The Commission has issued the enclosed Amendment No. 70 to Facility Operating License No. DPR-32 and Amendment No. 70 to Facility Operating License No. DPR-37 for the Surry Power Station, Unit Nos. 1 and 2, respectively. The amendments consist of changes to the Technical Specifications in response to your application transmitted by letter dated April 28, 1981, as supplemented May 15, 1981.

These amendments revise the Technical Specifications to change the heat flux hot channel factor ( $F_D$ ) to 2.18 for Units 1 and 2. These amendments also make editorial changes to the Technical Specifications.

SAFETY EVALUATION BY THE OFFICE OF NUCLEAR REACTOR REGULATION  
RELATED TO AMENDMENT NO. 70 TO FACILITY OPERATING LICENSE NO. DPR-32  
AND AMENDMENT NO. 70 TO FACILITY OPERATING LICENSE NO. DPR-37

SURRY POWER STATION, UNIT NOS. 1 AND 2

HOT CHANNEL FACTOR NORMALIZED

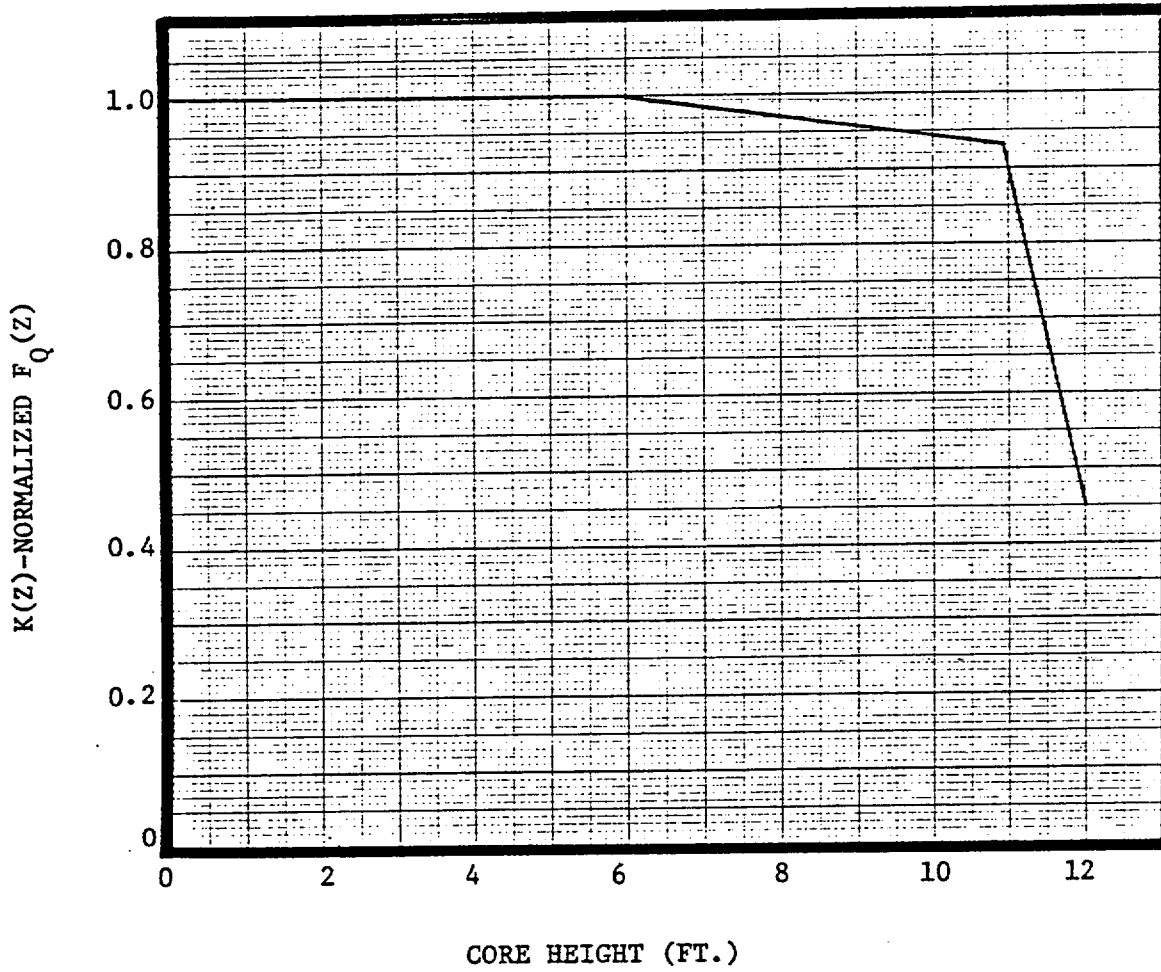
| <u>Remove Pages</u>       | <u>Insert Pages</u>             |
|---------------------------|---------------------------------|
| TS Figure 3.12-8(Unit 1)  | TS Figure 3.12-8(Units 1 and 2) |

$$F_Q(Z) \leq 2.18/P \times K(Z) \text{ for } P > 0.5$$

where P is the fraction of rated power at which the core is operating, K(Z) is the function given in TS Figure 3.12-8, and Z is the core height location of  $F_Q$ .

AXIAL FLUX DIFFERENCE LIMITS  
AS A FUNCTION OF RATED POWER  
SURRY POWER STATION

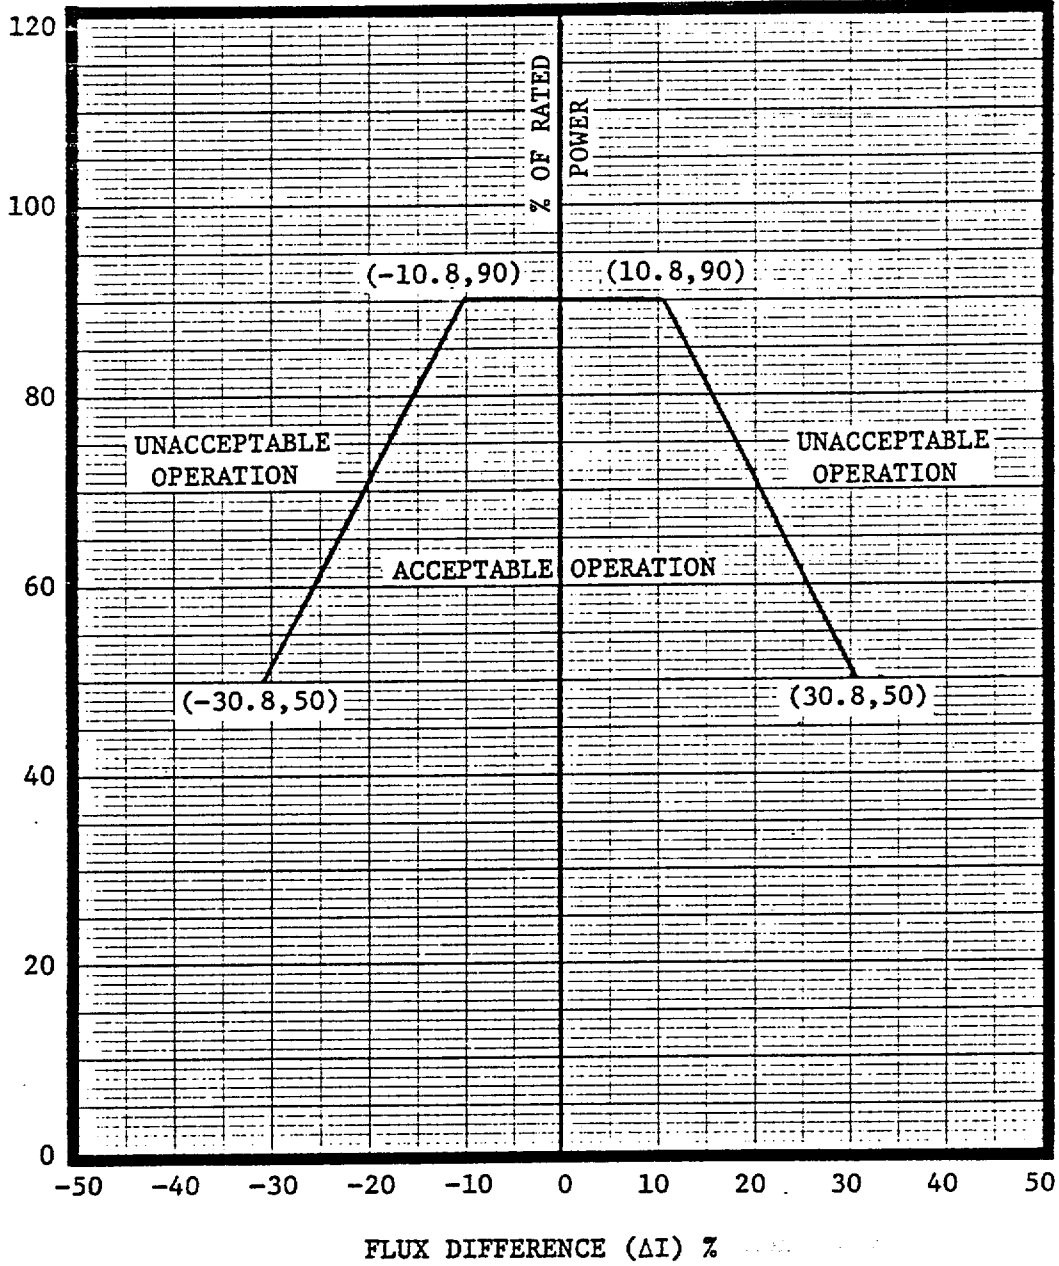
| <u>Remove Pages</u>       | <u>Insert Pages</u>             |
|---------------------------|---------------------------------|
| TS Figure 3.12-10         | TS Figure 3.12-10               |

- b. At a power level no greater than 90 percent of rated power,
    - (1) The indicated axial flux difference may deviate from its target band for a maximum of one hour (cumulative) in any 24-hour period provided the flux difference is within the limits shown on TS Figure 3.12-10.
